A-One Polar Ltd. (New Buildings)

28th May and 3rd June 2018

Observations

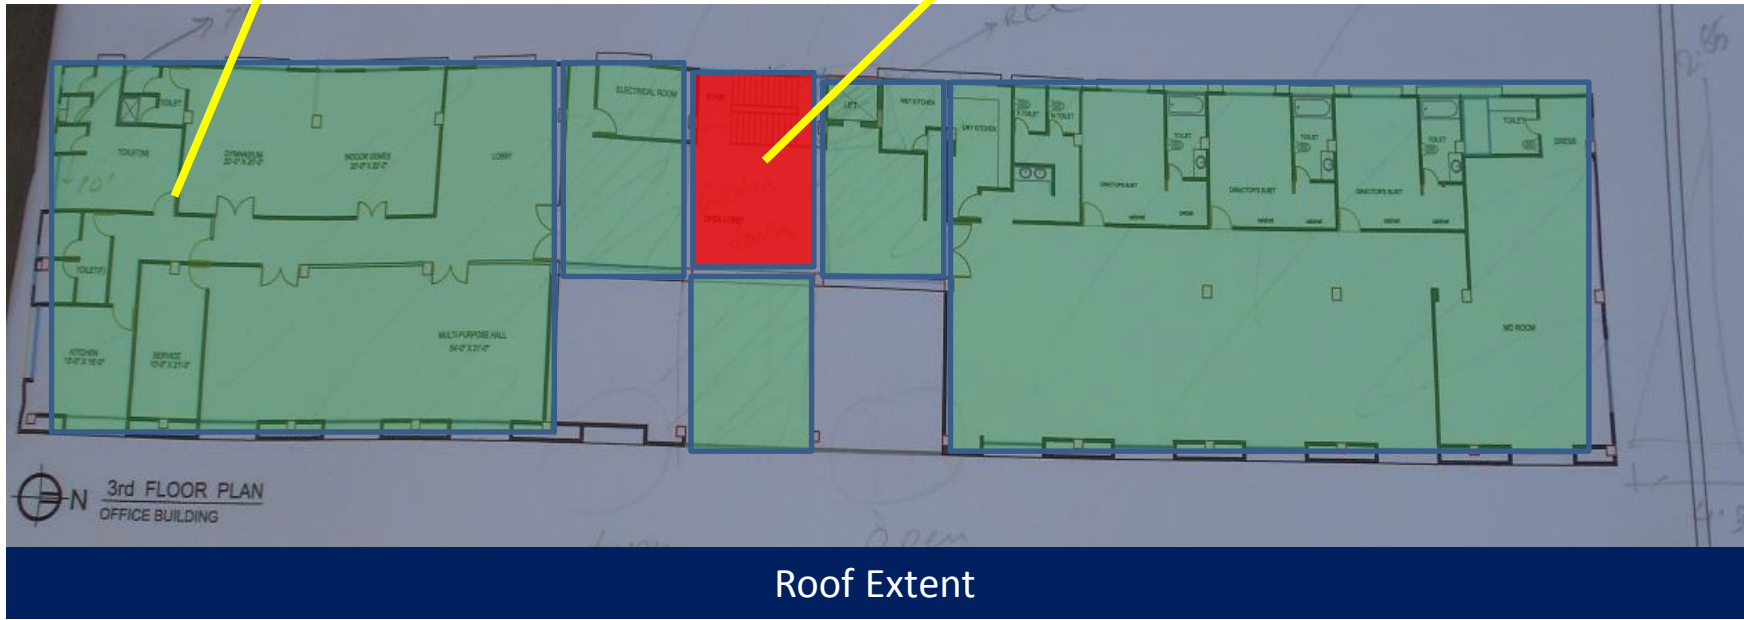
As-built drawing was found up to 2nd floor. No drawing was observed for roof truss. Column schedule of 3rd floor was found missing in the given As-built drawing.

Column layout plan

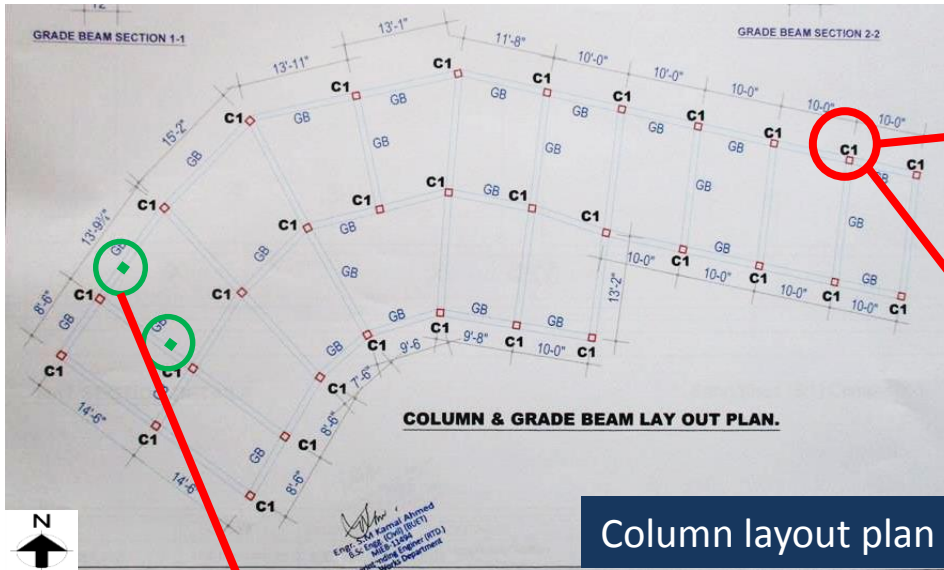
8 nos. rebars are shown in column schedule where 6 rebars were found onsite. Also, the column layout of the provided drawings did not match with on site arrangement. Additional columns were found during inspection which has been marked as green.

6 Rebars in stair column

Additional column

3rd FLOOR PLAN

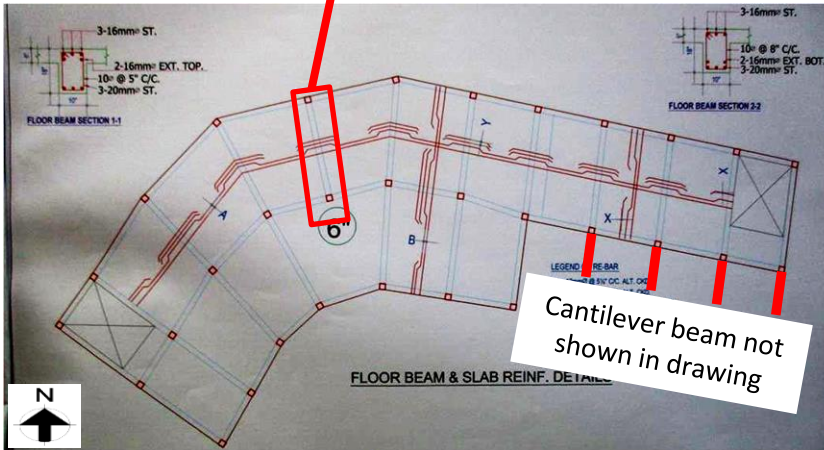
Beam missing in 1st & 2nd floor

Truss on 3rd floor

4x1000 ltr. Water Tank and a mast on 3rd floor

Cantilever beam not shown in drawing

Floor beams were missing on marked location of 1st & 2nd floor. Undocumented roof truss was found on 3rd floor . Water tanks were observed on 2nd floor roof (4x1000 litre). Also, Cantilever beams were found in south direction of the building but not shown in as built drawing .

Column Schedule

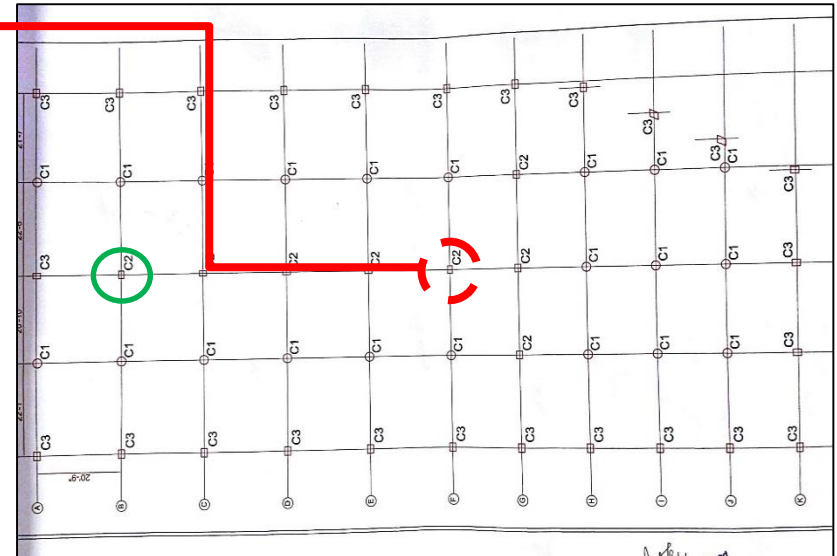
C2 Column was measured 500mm instead of 550mm

Diameter of C1 Column was measured 600mm instead of Diameter 650mm.

The dimension of all C1 and C2 type columns were found smaller than column schedule. Diameter of C1 column was measured 600mm instead of 650mm and C2 column dimension was found 600mm instead 550mm. Moreover, on B-3 grid (marked as green on layout) the orientation of C2 column didn't match with column layout plan.

Floor beam layout Plan

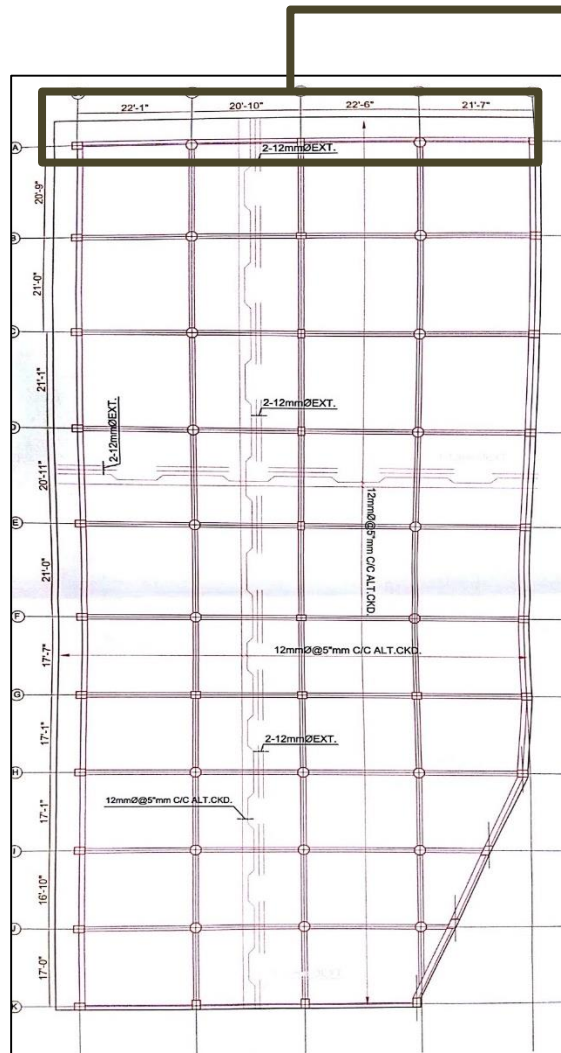
Beam layout on site didn't match with as-built drawing. In 1st and 2nd floor beam wasn't found on the marked portion.

Location of the missing beam

On north face, cantilever beams are present which aren't shown in as-built drawings.

Floor layout plan

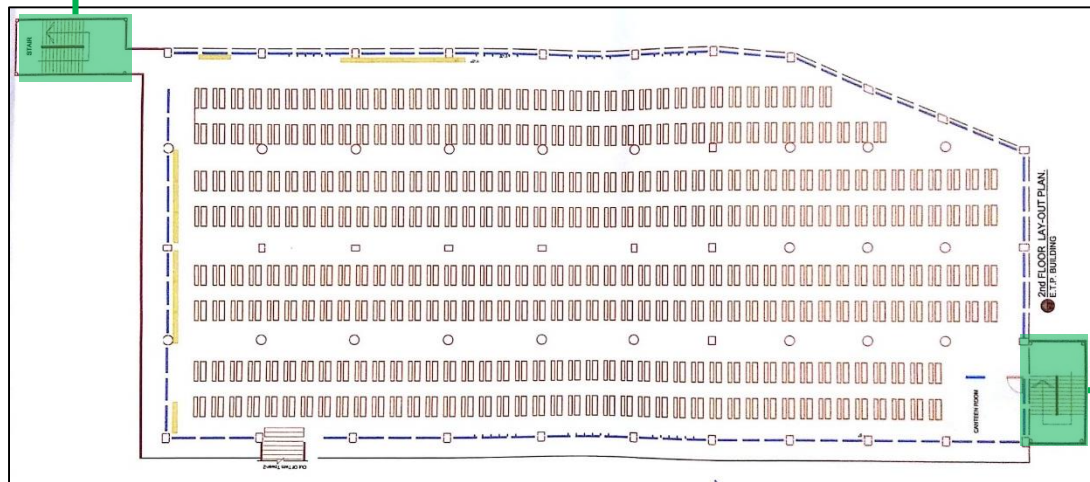
Emergency Steel stair on north face.

Emergency Steel stair on south face.

No document was found of emergency steel stair on north side and south side. Factory Engineer is required to prepare as-built drawing (structural and architectural) and carry out stability check against the lateral loads.

Uncontrolled loading

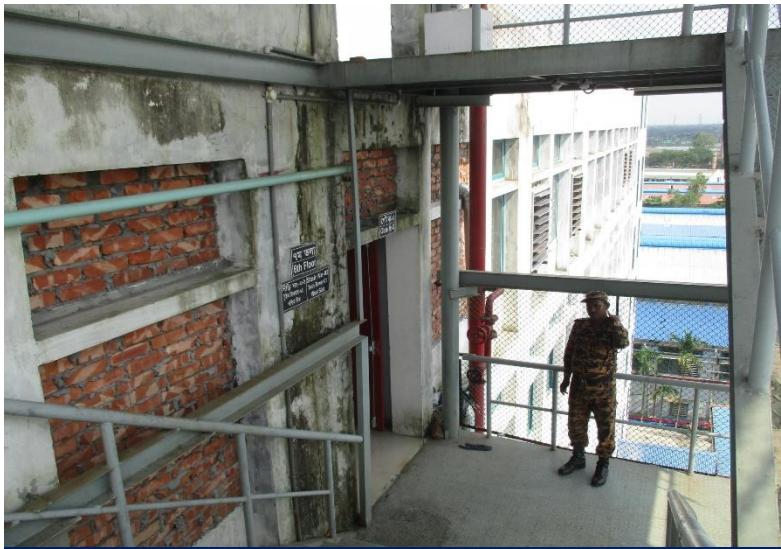
No load management program (i.e load restriction height marking, posting load plan, signage) was implemented. Factory engineer is required to implement floor load management.

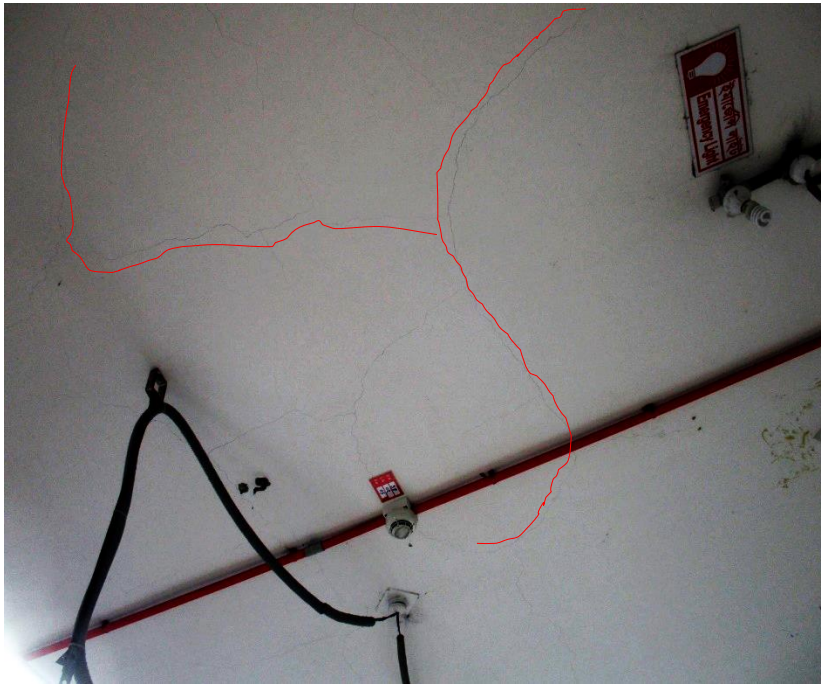
Steel stair adjacent to Twin Tower-1

Steel stair in between Twin Tower-2 to ETP

Steel connecting bridge from Twin Tower

Some steel stair, roof frame and connecting bridges were found adjacent to the Twin Tower buildings having no structural details.

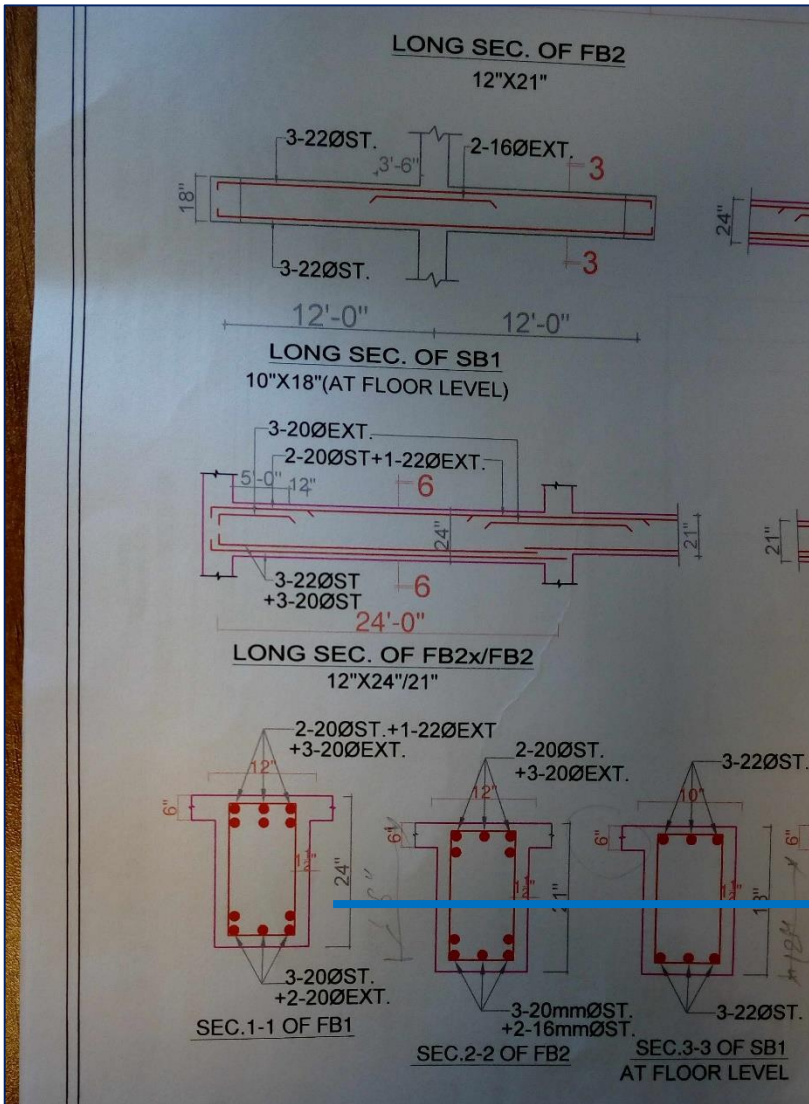
FB-1 d/s was found 375mm instead of 450 mm in the roof top.

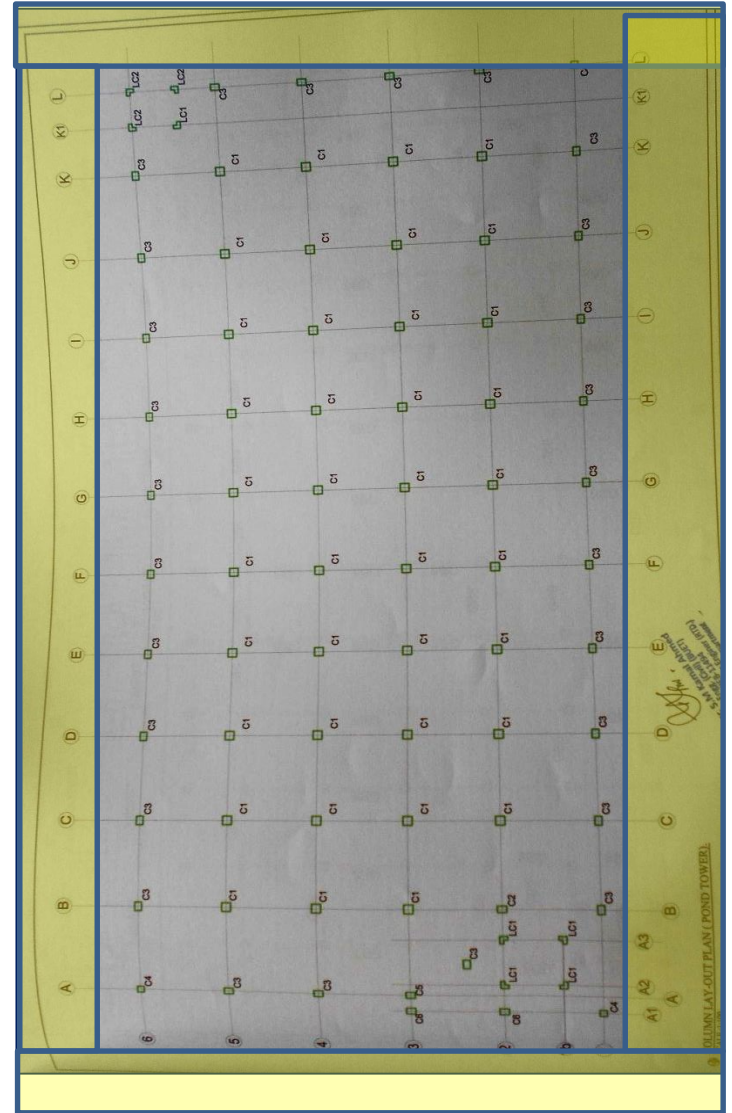
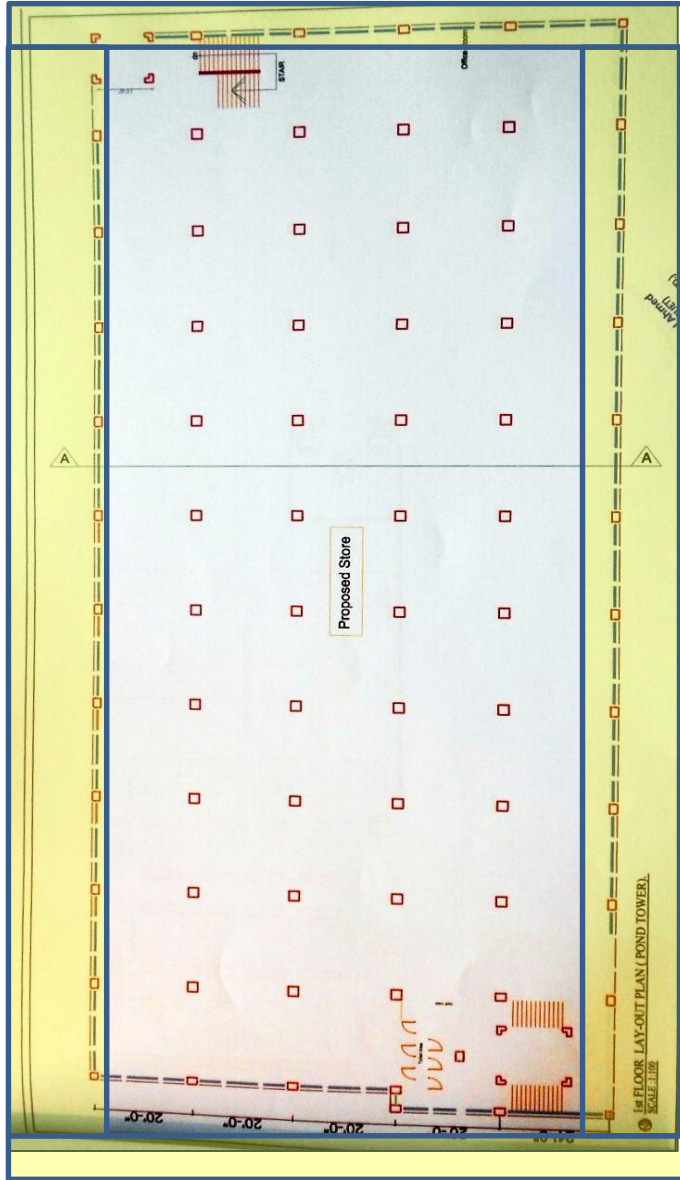
Grid dimension missing in Architectural and structural drawing. Floor layout (PW, Build Up) need to update on architectural drawings.

Loading condition

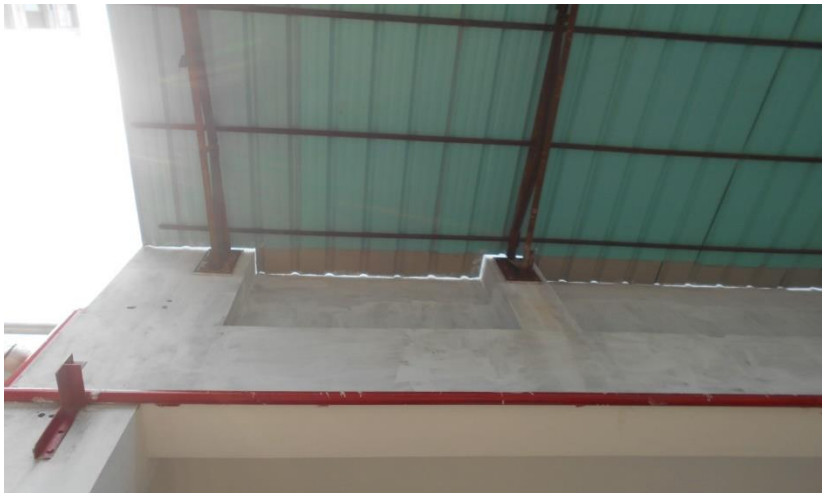
Design concrete strength was considered 3500 psi (24.13 MPa). Equivalent concrete strength was found 3190 psi (22 MPa). Live load considered 4 kPa for all floors. Factory is required to check the design report considering live load above 3 kPa with the value obtained from core test report. Otherwise maintain live load below 3 kPa.

Beam layout

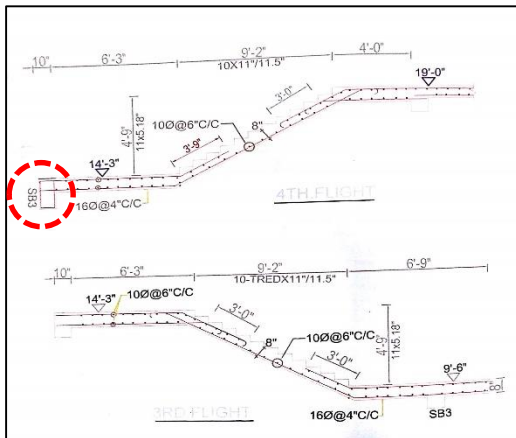
Beam layout on site didn't match with as-built drawing. In 6th floor staircase, the landing beam SB3 wasn't found on site. But the beam was shown in as-built drawings.

COLUMN SCHEDULE

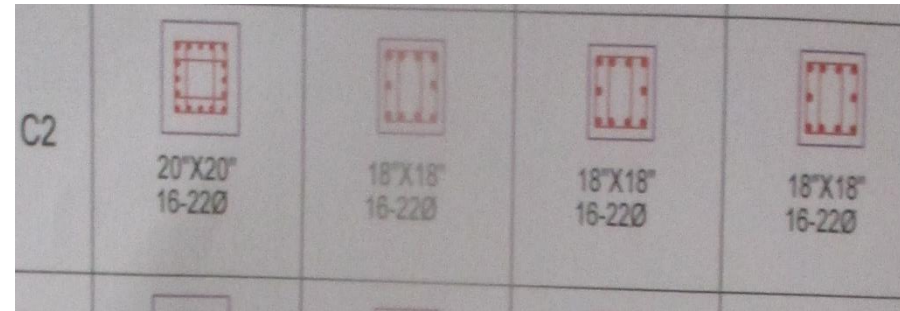
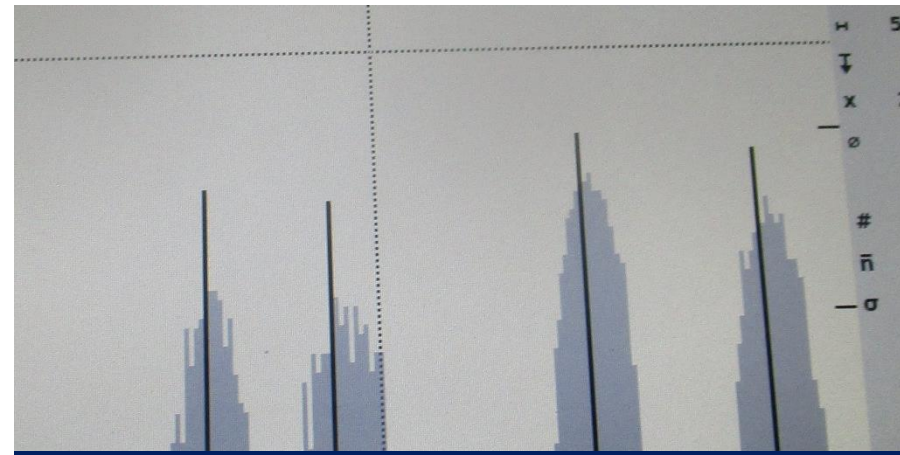
During inspection, 12 rebars were found by ferro scan (4 rebars each side) in central C2 columns where provided drawings shows 16 rebars.

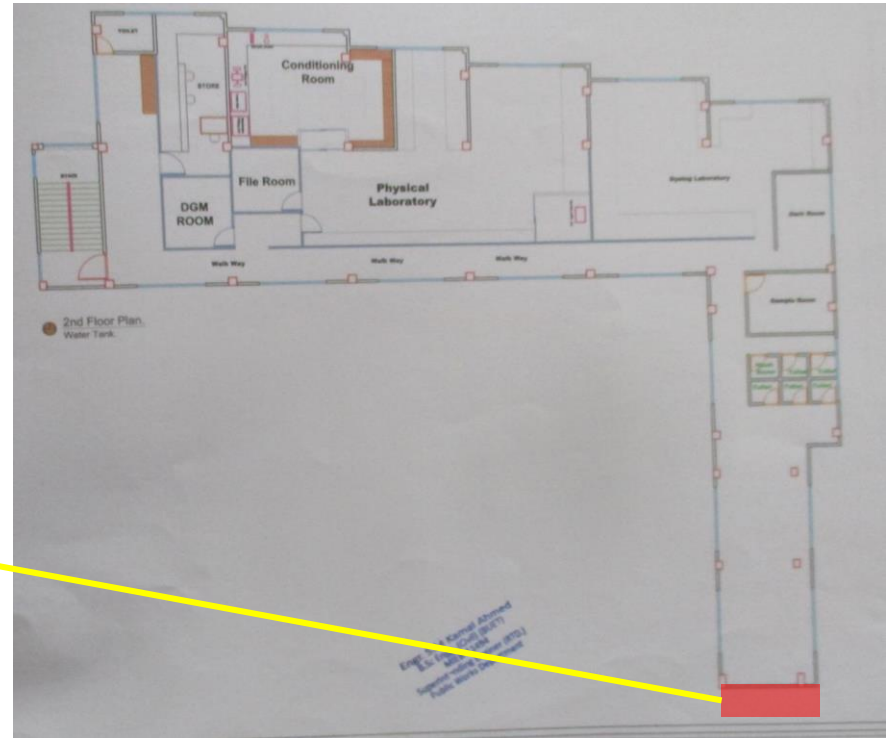
Large vessel were found resting on ground floor slab/top slab of U.G.W.R. So, factory engineer is required to check the adequacy of slab due to the heavy loading.
